STATE OF CALIFORNIA
REGIONAL WATER QUALITY CONTROL BOARD
CENTRAL COAST REGION

STAFF REPORT FOR REGULAR MEETING OF DECEMBER 5, 2008

SUBJECT: Paso Robles Class III Landfill, San Luis Obispo County—Revised
Waste Discharge Requirements Order No. R3-2008-0050

FIGURE 1. Select VOC concentration trends since 2000 from Landfill lysimeter Monitoring Points. LS-V2= Lysimeter Monitoring Point No. 2; PCE= perchloroethene; DCA= dichloroethane

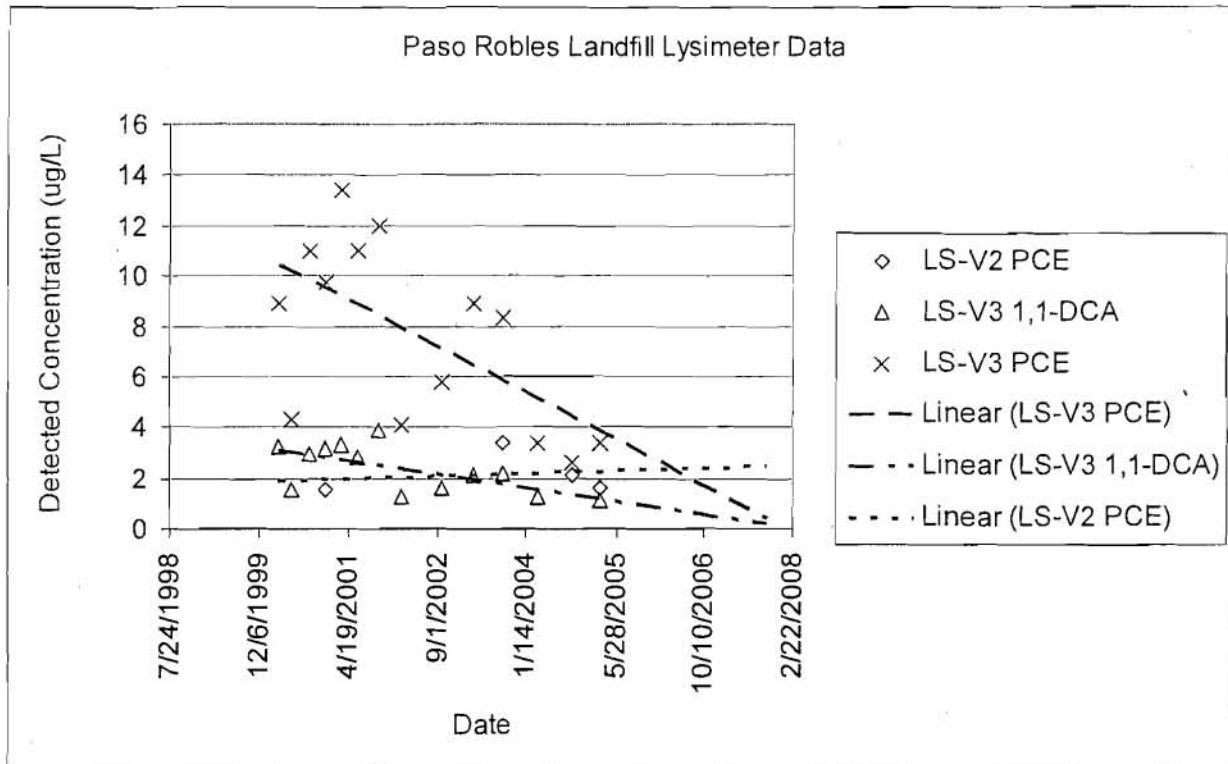
2) The pre-draft Staff Report suggests that existing lysimeters be retained and incorporated in the monitoring program. Historically, sampling (via vacuum pumping) has not produced sufficient liquids volumes to analyze for all required monitoring parameters. Since 2005, the majority of the lysimeters have been dry. It is recommended that the need for continued semi-annual lysimeter monitoring be reconsidered as part of the proposed WDRs.

Water Board staff's response: We recommend retaining the lysimeters in the monitoring program because the information obtained from them is useful for assessing potential release or cleanup of a release from the landfill, as indicated by the graph in this staff report. The groundwater is very deep (greater than 250 feet below ground surface), so there is a very thick unsaturated zone beneath the site. Therefore, a significant amount of contaminant mass could potentially "load up" the unsaturated zone before an impact is detected by the groundwater monitoring wells. The lysimeters, along with the soil-gas monitoring probes, provide a good early warning system. As for the lysimeters going dry, wetter years may produce sufficient water for sample collection and there are also procedures that would improve the performance of the lysimeters. In addition, the lysimeter's dry

condition may suggest the landfill gas extraction system is drying out the local unsaturated zone. This is useful information provided by lysimeter monitoring. However, historical monitoring shows that VOCs were primarily the only constituents analyzed by the laboratory from the lysimeter samples. As a result, Water Board staff added an analyte priorities list in the MRP that places VOC sampling as the top priority, followed by general minerals and metals, etc.
